California Energy Commission
<b>DOCKETED</b>
<b>11-RPS-1</b>
TN # 67608
OCT. 08 2012

California Energy Commission  
 Re: Docket No.'s 11-RPS-01; 03-RPS-1078;  
 and 02-REN-1038  
 1516 Ninth Street  
 Sacramento, CA 95814-5512

Re: September 21, 2012 workshop; 2008-2010 RPS Procurement Verification and Proposed SB X 1-2 RPS Verification

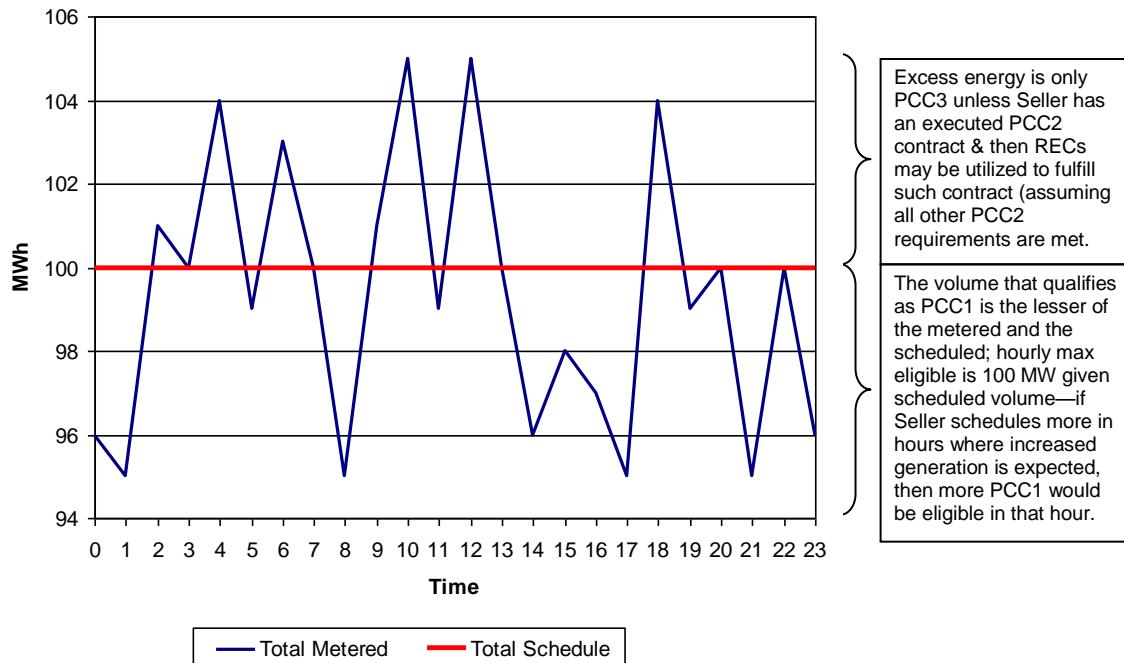
Under a single contract, a company such as Iberdrola may sell both the RPS energy and provide the firming and shaping services—and, as a result, this requires a transaction with an affiliate. Iberdrola understands that the intent of the law and rules is to ensure that for PCC2, new increments of *both* energy and RECs are procured. (Please see Attachment B for a diagram further outlining this structure.)

# PCC1 – Scheduled into a CBA - Initial Verification Expectations

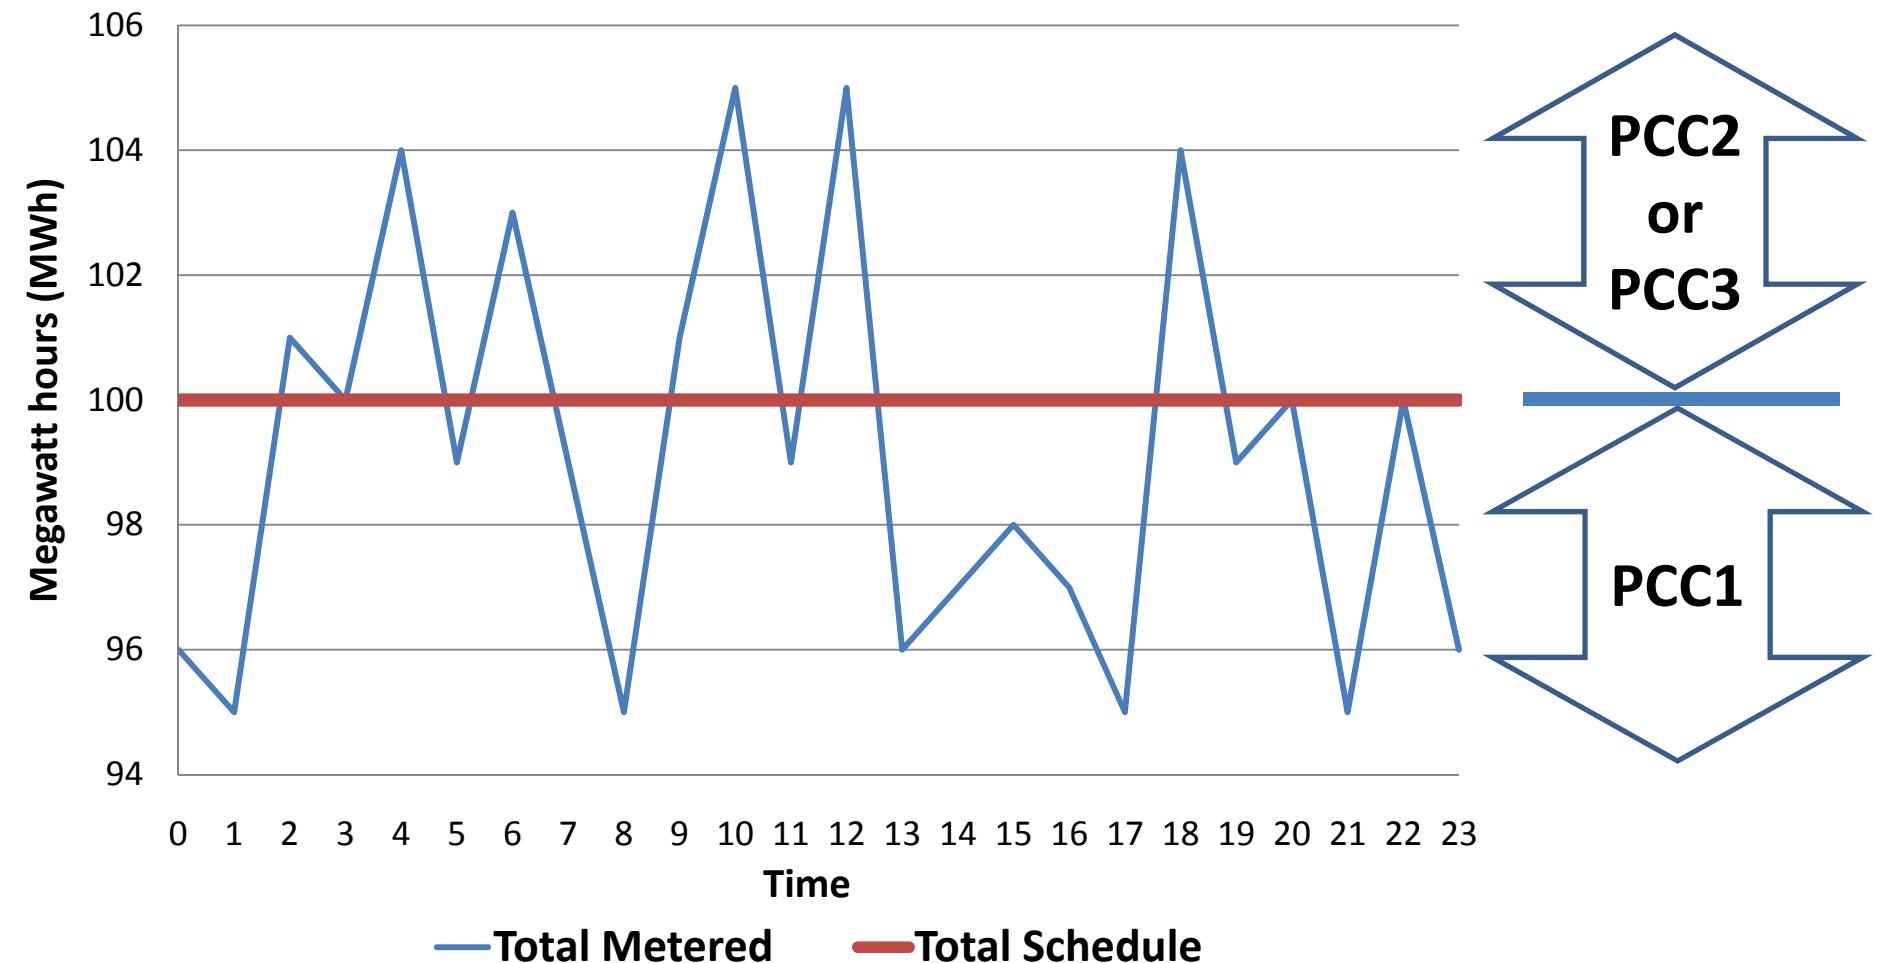
In this light, the table presented by CEC staff at the workshop (Presentation Slide 20, Attachment A) is on the right track for verifying PCC volumes but may be more user-friendly if formatted as an Excel spreadsheet. A separate database is not necessary for each facility and would be burdensome for both market participants and the CEC. Instead, a simple Excel spreadsheet may be utilized—adding a tab for each contract or asset. The Excel spreadsheet may easily be converted into a PDF file, which then serves to ‘lock’ the data and not allow for further editing, which ensures staff that the data cannot be changed later.
